Addendum #2

Bid Opportunity: 24-7539-RFT - Preston High School Interior Ramp Washroom Upgrade

ADDENDUM 02

PRESTON HS - RAMP AND WASHROOM RENOVATIONS

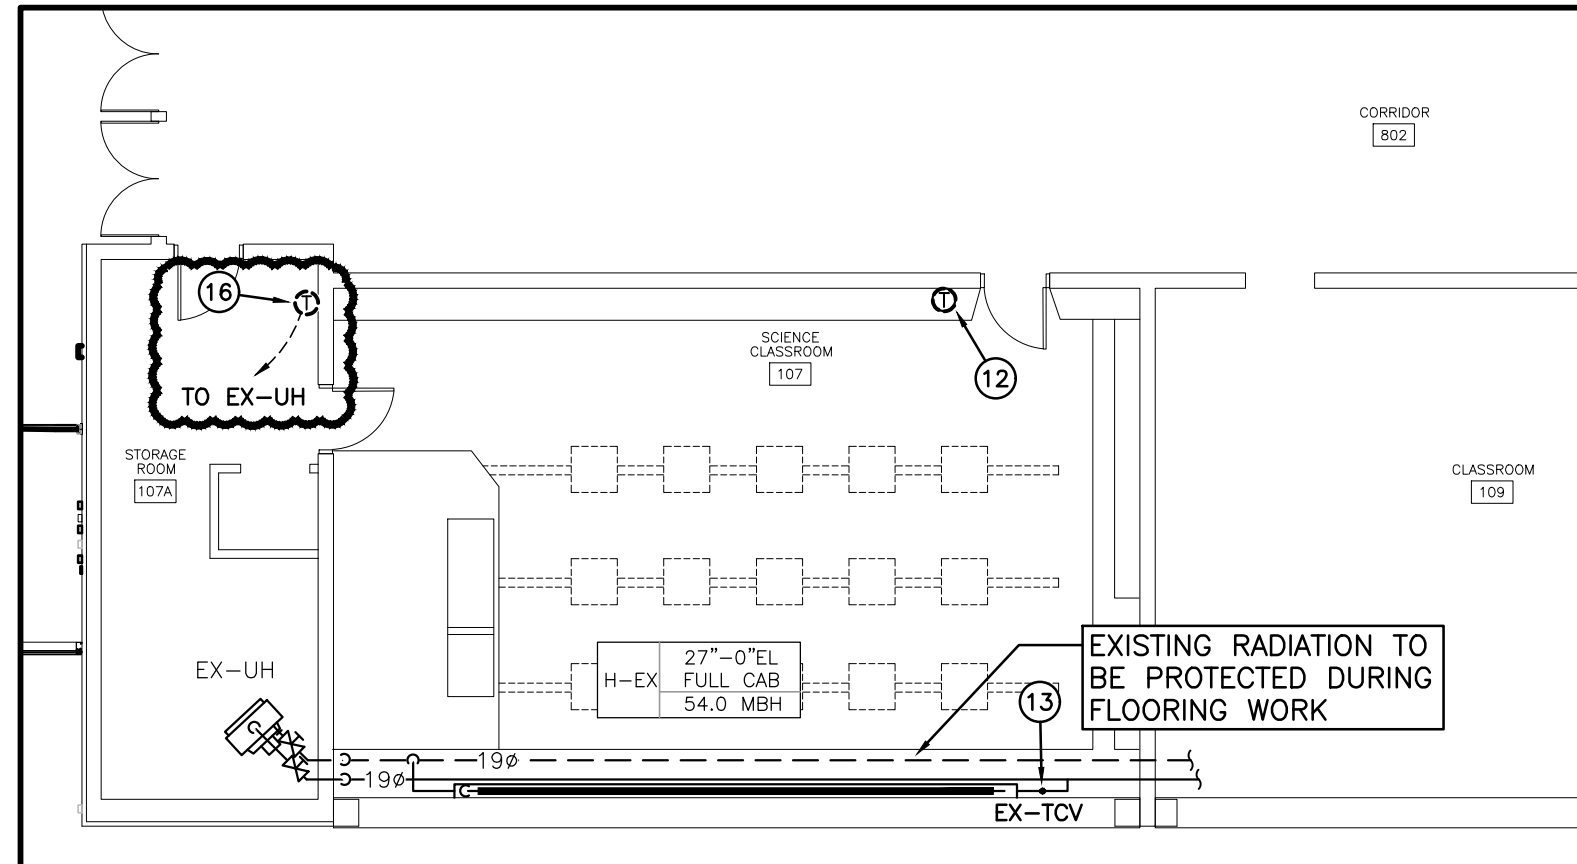
- 1.0 Reference Drawing M2.1 and Attached Sketch AD02-M01
 - .1 In Storage 107A, provide new thermostat for existing unit heater as indicated on sketch AD02-M01.

SCALE:	As indicated	SHEET NO:	E2.3
DATE:	2024-01-30		
PROJECT NO:	2023-0705-11		
DRAWN BY:	KZ		
CHECKED BY:	SD

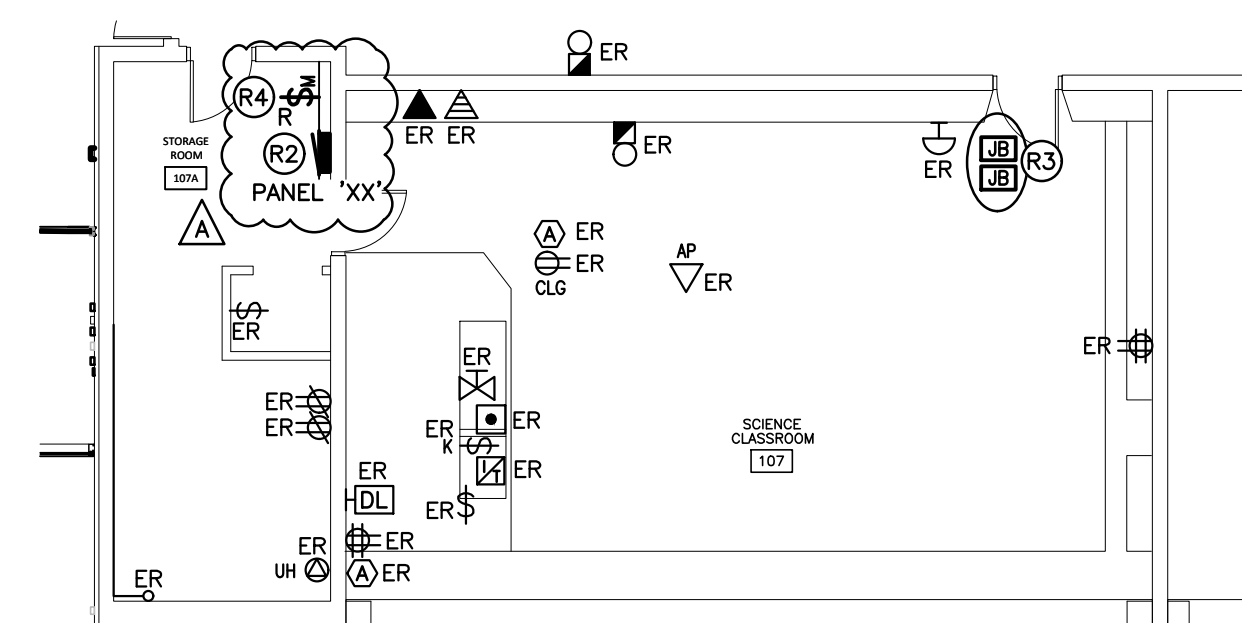
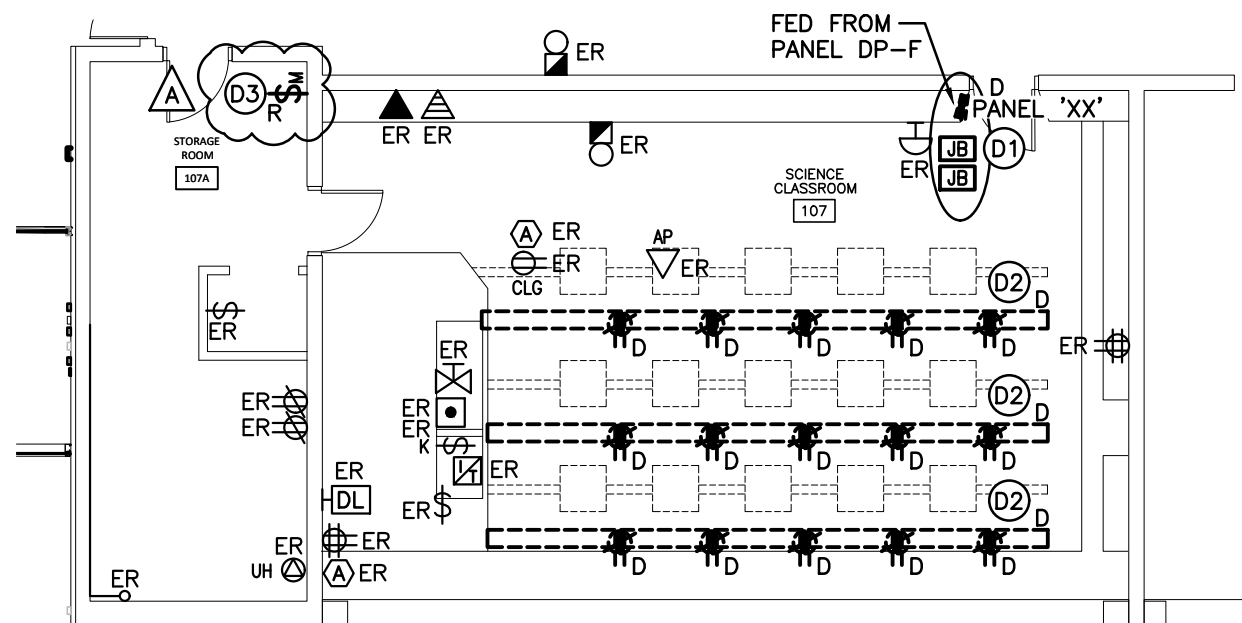
- 1.0 Reference Attached Reissued Drawing E2.3
 - .1 In Storage 107A, relocate existing switch as indicated on reissued drawing E2.3.
 - .2 Revise new panelboard to recessed mount as indicated on reissued drawing E2.3.

- R1 REWORK EXISTING LIGHTING CIRCUIT WITHIN THIS AREA TO SUIT NEW LIGHTING CONTROL MOUNT SWITCHES IN OLD PANEL TUB.
- R2 PANEL SHALL BE AS FOLLOWS:
RECESSED MOUNT
100A 120/208V 3PH 4W
22KAIC
MAIN LUGS ONLY
RECESSED MOUNT
100% NEUTRAL
30 CIRCUIT MINIMUM C/W -
14 X 15A-1P BREAKERS
- PROVIDE THE FOLLOWING NEW BREAKERS:
CIRCUIT BREAKER DEVICE
XX-1 20A-1P 5mA GF STAFF WASHROOM #101 HAND DRYER
XX-2 15A-1P 5mA GF WASHROOM FAUCETS REC.
- NOTE: RECONNECT BRANCH CIRCUITS MADE AVAILABLE DURING DEMOLITION PHASE AND BACK FEED PANEL.
- R3 FROM JUNCTION BOXES, PROVIDE NEW MAINS WIRING (4#8 T90 CU IN 21mmC) AND BRANCH CIRCUIT WIRING TO NEW PANEL BOARD LOCATION. TERMINATE WIRING ON TERMINAL STRIPS TO SUIT RECONNECTION. VERIFY EXACT CONDITIONS ON SITE AND COORDINATE RE-FEED METHOD WITH CONSULTANT.
- R4 RE-INSTALL EXISTING SWITCH IN NEW FURRING WALL.
